**HUMAN FACTORS ENGINEERING
EVALUATION AND IMPROVEMENT OF THE
VIRGIL C. SUMMER NUCLEAR STATION CONTROL ROOM**

50/395

November 10, 1980

4.2 H.V.A.C. PANEL

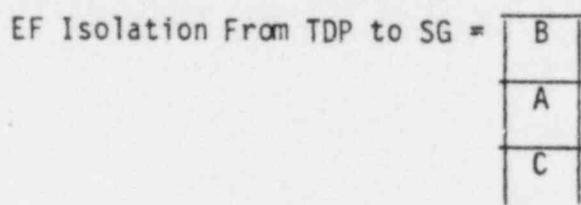
- a. Mimic is color coded but the coding is not carried out over the controls and the pane's (Category 2).
- b. Damper Controls and Mimic for LOOP A, LOOP B, TRAIN A, TRAIN B, do not appear to correspond. Cannot tell on the mimic what is a loop or what is a train. The control labeling is very confusing and not apparent on the mimic (Category 2).
- c. There are large numbers of fan controls grouped together and it is not easy to find a particular fan by number. Also, the arrangement of those controls does not correspond to their relative position on the mimic (Category 2).

- d. Considerable glare on mimic board, particularly at the top of HVAC panel (Category 2).
- e. Mimic board is too high for a 5th percentile person to read (Category 3).
- f. CMC component identification numbers are hard to read when legend is not illuminated (Category 3).
